TECHNICAL NOTE

Project Title: Beane Solar Farm

Report Reference: 794-PLN-TRP-JNY11727-04

Beane Solar Farm Technical Note

Appendix 4 - Tractor and Trailer Swept Path Analysis

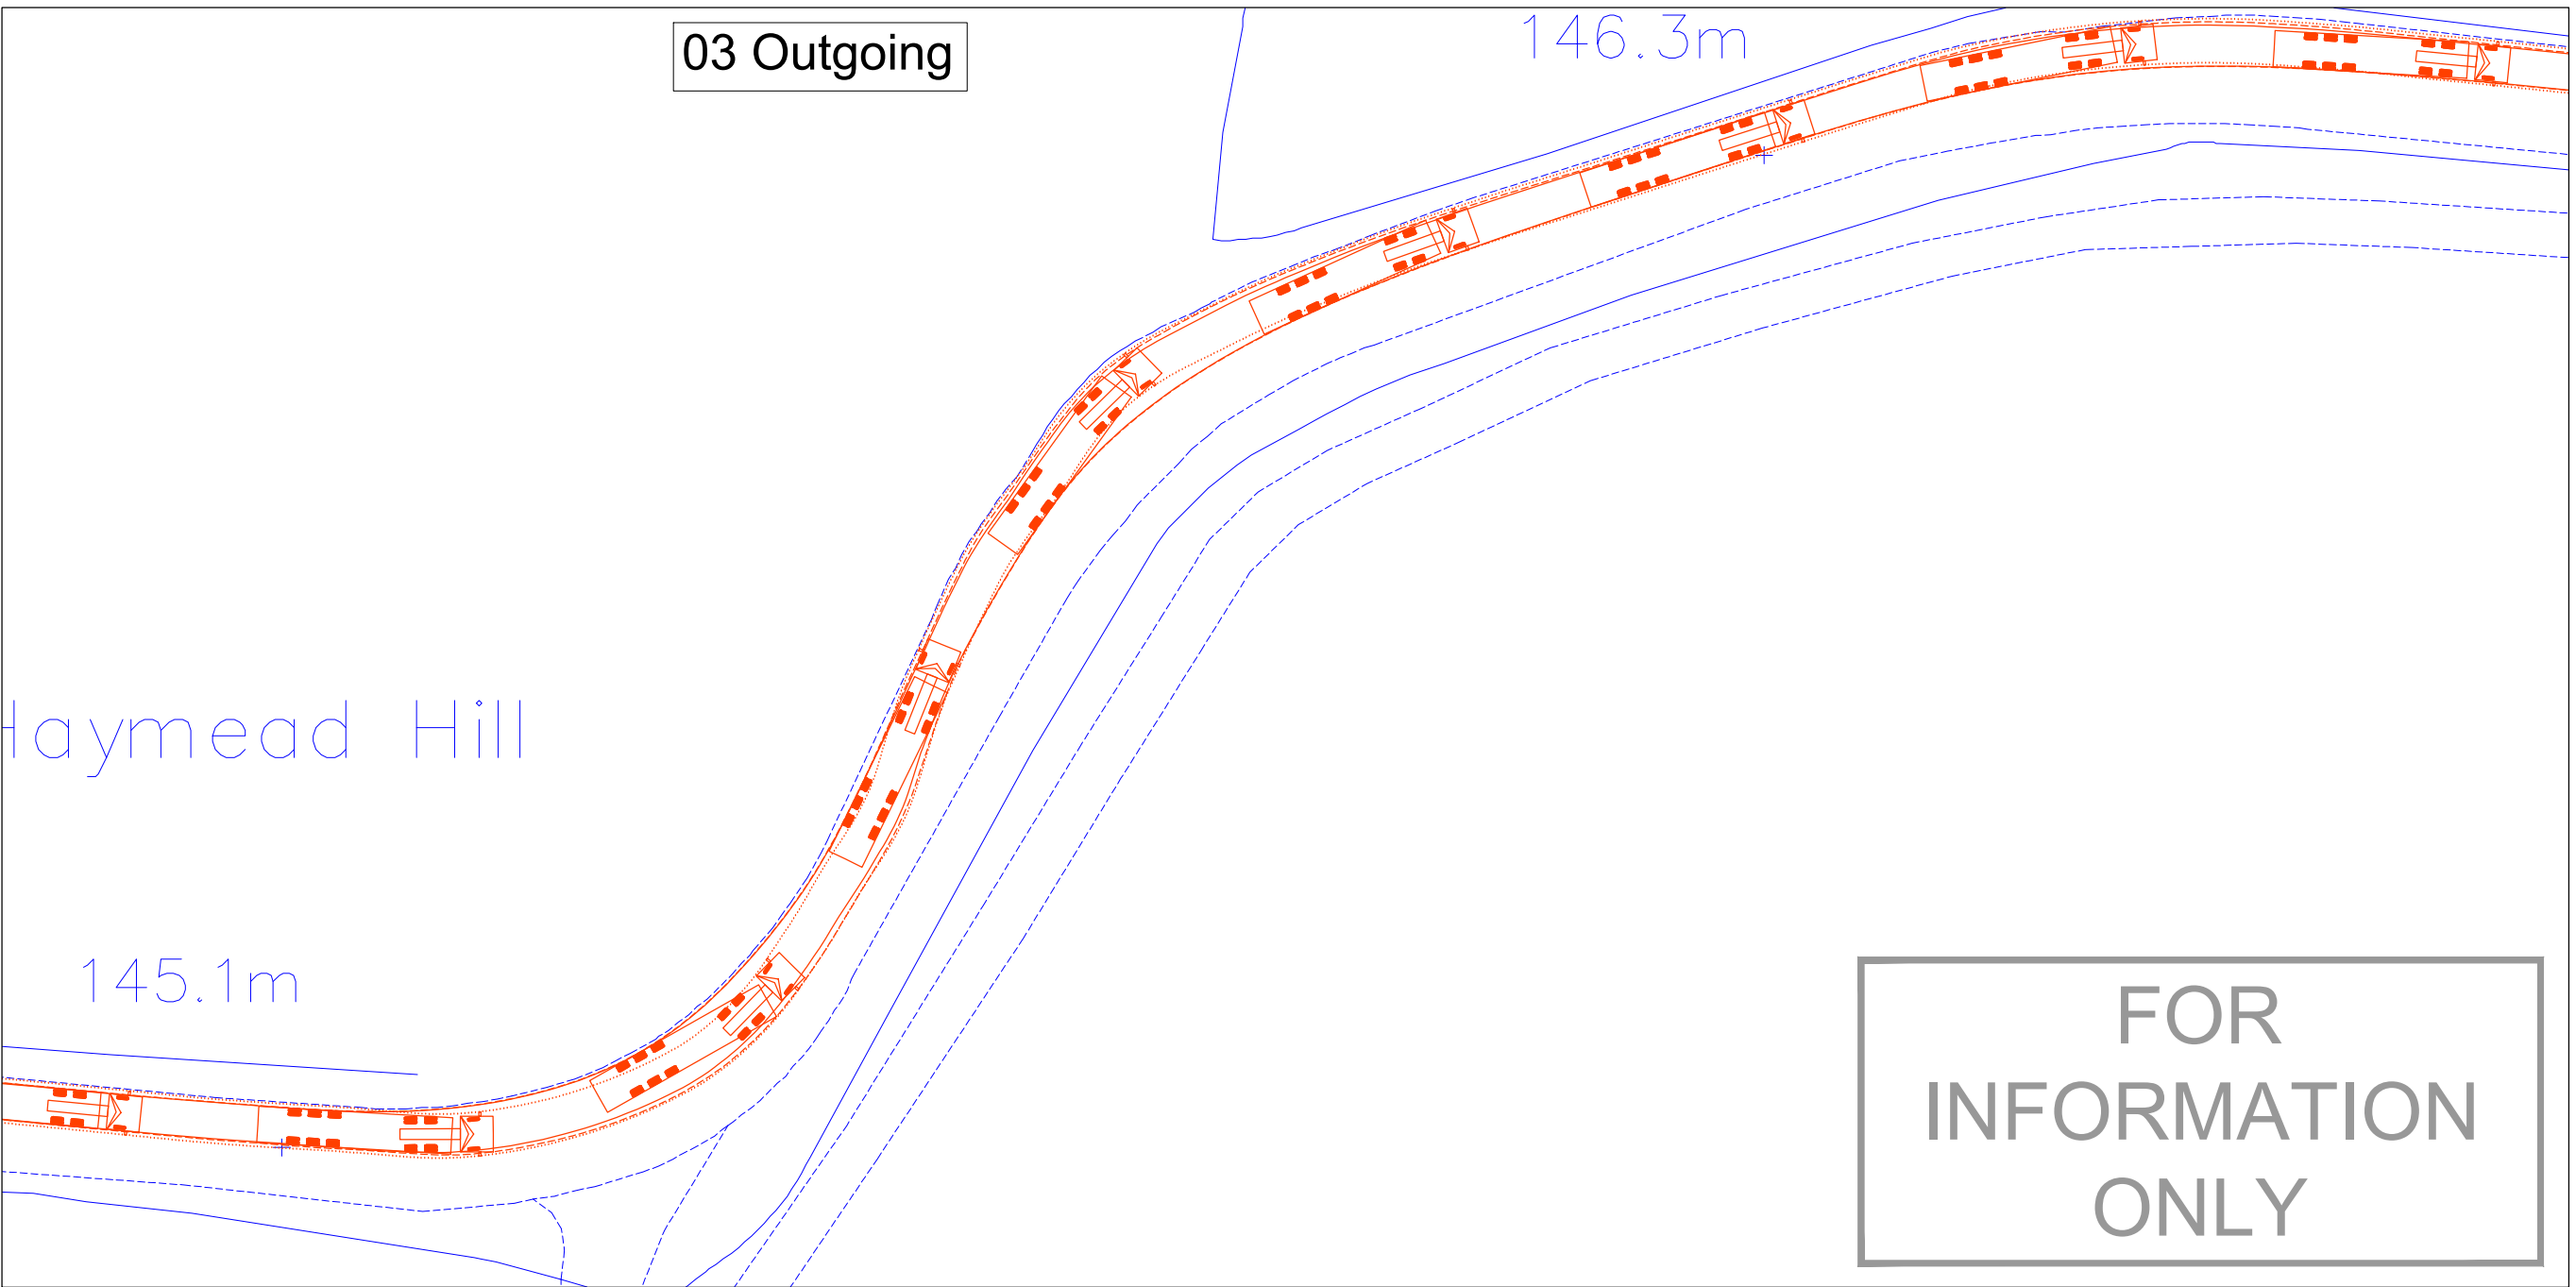
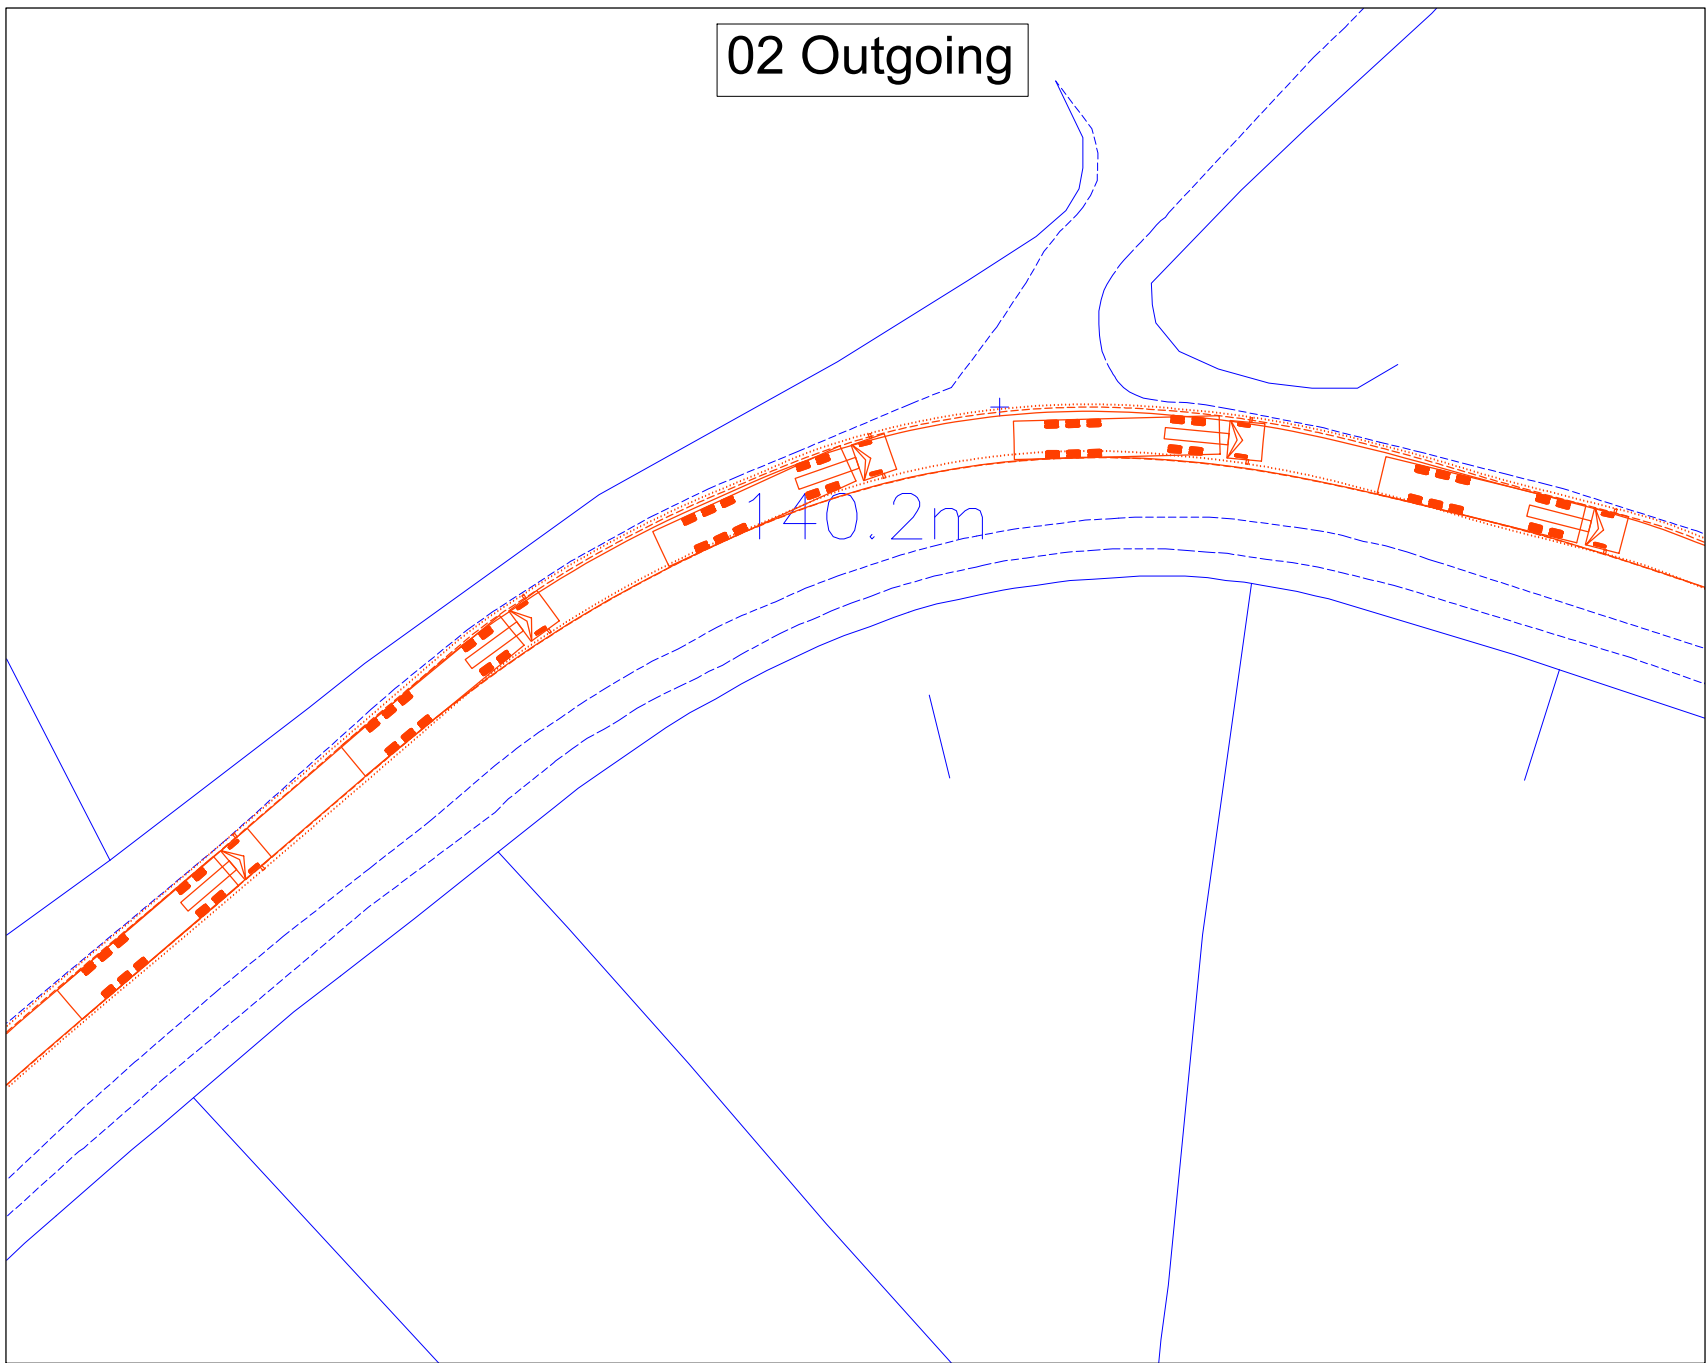
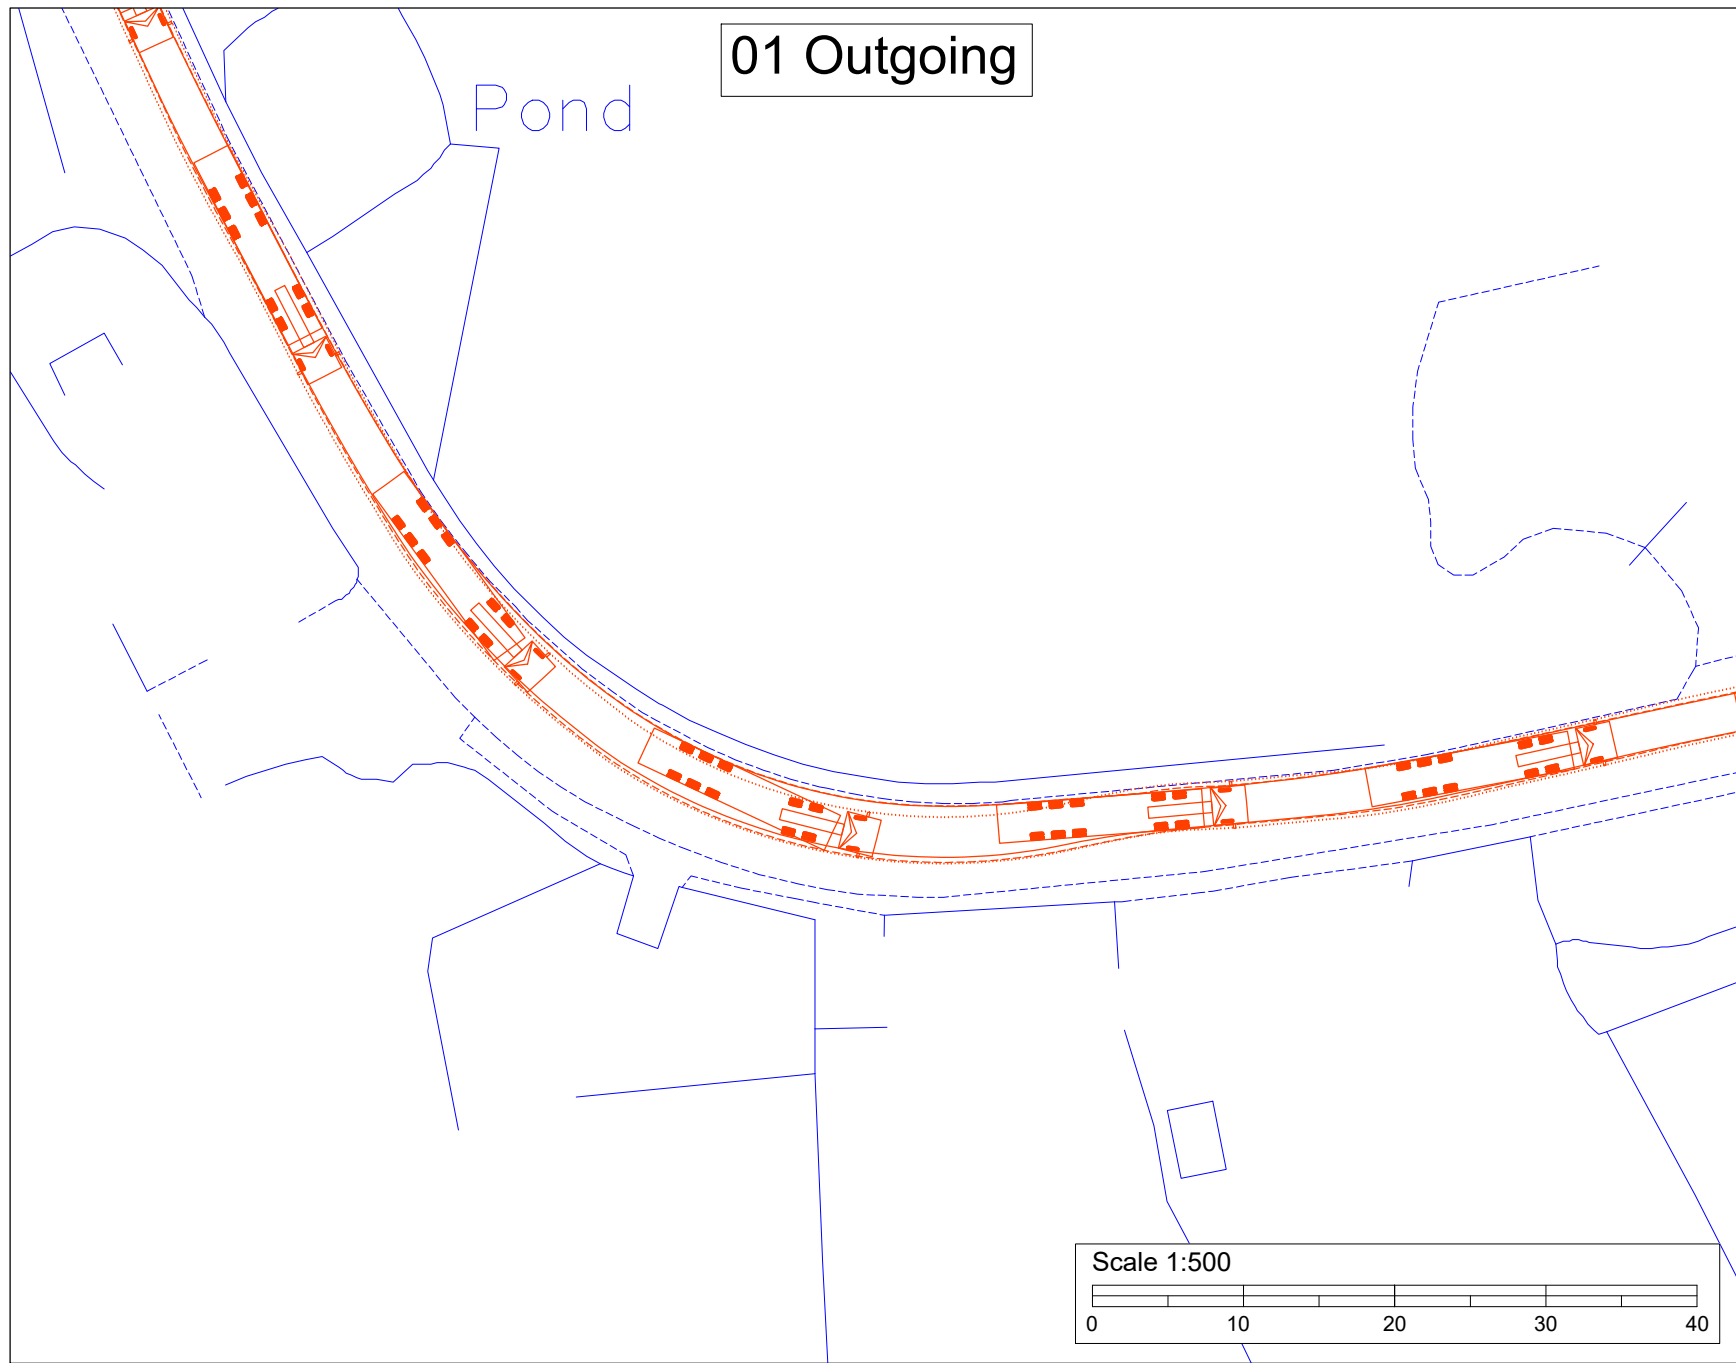
- Drawing number 05003-RES-ACC-DR-PE-003 Rev 1 and 05003-RES-ACC-DR-PE-004 Rev 1 illustrates a 16.5 metre lorry entering from Cromer Heath which is not suitable for such a vehicle. The CMP says that this access will not be used by HGV's - this needs to be clarified.

- 1.27 Paragraph 4.5 of the CTMP states that construction materials will all enter the site via the A507 access into the northern parcel, and materials designated for the southern parcel will be transhipped onto smaller vehicles (e.g. tractor and trailers, or light goods vehicle) within the temporary construction compound (west from the A507). From here, they will be moved internally within the site, and to the southern compound for storage and transit between the northern and southern land parcels via tractor and trailer along Cromer Heath. This approach will reduce / minimise the distance travelled by construction HGVs along constrained sections of the public highway, and appropriate traffic management measures can be adopted where necessary.

- 1.28 A swept path of a tractor and trailer moving through the southern access, to and from the north, is shown at **Appendix 4**.
